Q&A from Day 1

E1039 Collaboration

12/2

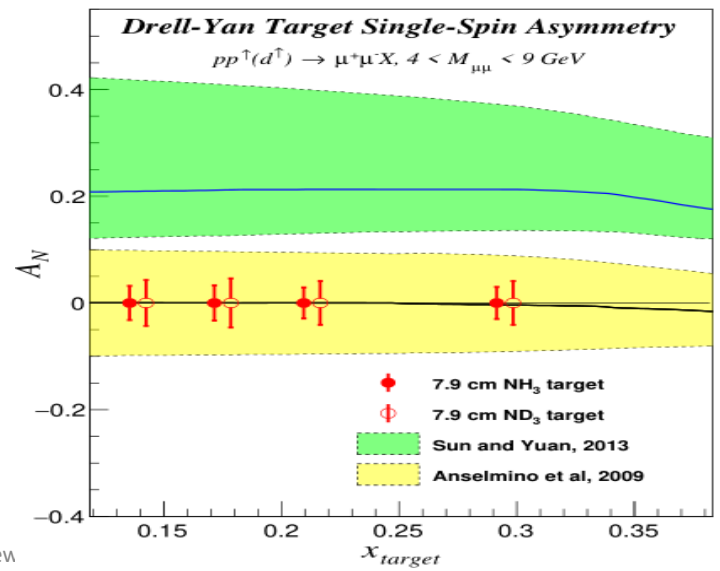
Q3: How much tolerance is there in the Figure of Merit if performance is not as expected, due to lower intensities to avoid magnet quenches, or less effective polarization, or lower bunch duty factor, etc?

- Lower duty factor will impact us significantly, but given AD has been consistently delivering high quality beam during the last run of the E906, we consider the risk to be very low

- Assuming 80% average pol., and 1.5E18 "useful" POT, we expect to have 4-5% statistical uncertainty for each of the 8 points
- If average pol. is only 60%, the expected uncertainty will be 25% larger
- If the quench threshold is a factor of 4 worse, the expected uncertainty will be a factor of 2 larger
- If both turned out to be true, we will reduce the number of bins in x_{target} from 4 to 1, and achieve a single measurement around $x \sim 0.2$ with the uncertainty between 5 to 6%

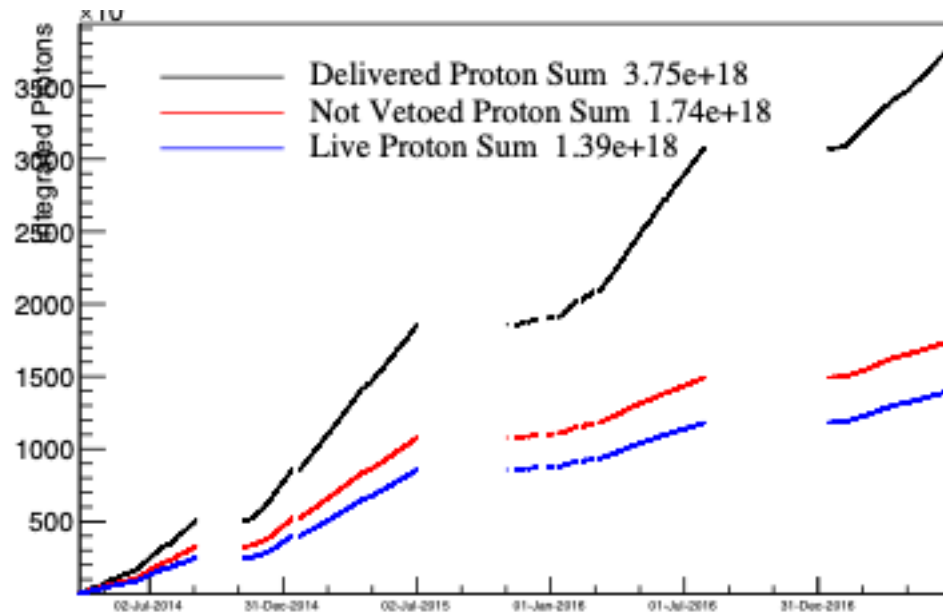
Q4: Summarize the activity spreadsheet, categorize the remaining QC - what needs pressure testing, what follows from ASME standards, what still needs final development, etc.

For the target, the answer is more complicated:

- Our cryogenic engineer is still learning about our system and learning how best to advise us
- Possible vessels/piping that have been discussed as possible need pressure tests some of which would be challenging or impossible to perform standard pressure test and how to proceed has not been clearly determined
 - Possible pressure tests: Fridge separator, nose/shell, bellows, U-tube, He-gas manifold, separator line(in cave), manometer line, magnet relief (in cave), nitrogen relief (in cave)
 - Built ASME: Quench line, magnet pump line and connection to KNF, separator one in penetration, backfill line

H3XT Hodoscope Plane Efficiency

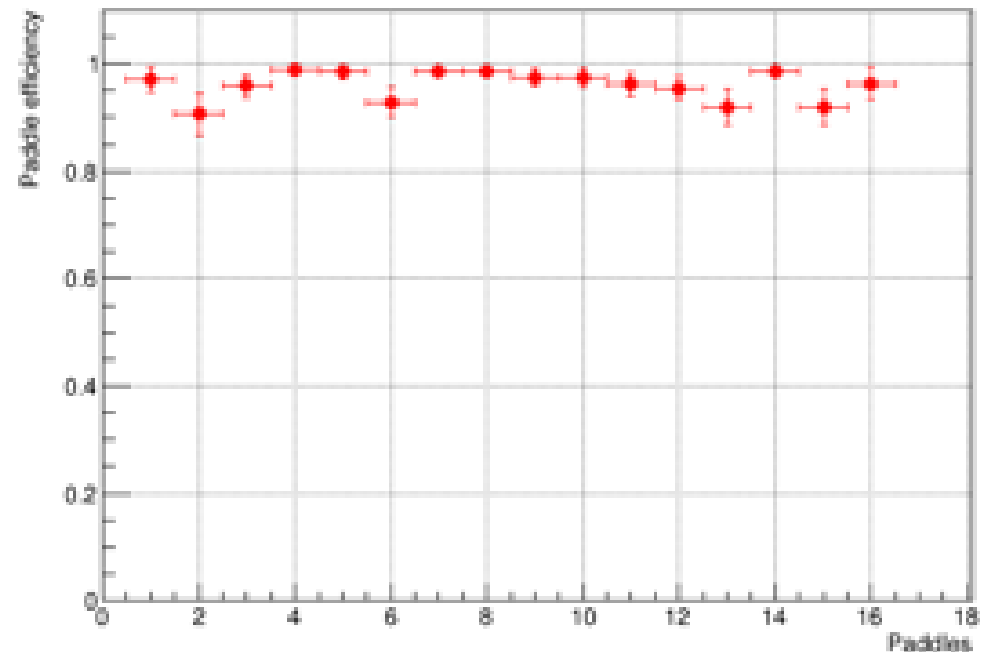
Q7: When was the last time SeaQuest took data, and what is the status of the rest of the detector elements (not the new portions) that are necessary for the physics you want to accomplish?

In this measurement, a cosmic ray must satisfy a trigger requiring hits in the station-2 and station-4 hodoscopes, and then a straight-line track is formed using space points from the station-2 and station-3 wire chambers and the station-4 proportional tubes. That track is interpolated to the station-3 hodoscope plane, and we can predict which paddle it should have hit.

Then we ask if that paddle did indeed have a hit; the fraction of times we see a hit there is the efficiency.

As is seen in the figure, all paddles in the H3XT plane have efficiencies in excess of 90%, and the average efficiency of the whole plane is calculated to be 97.5%.
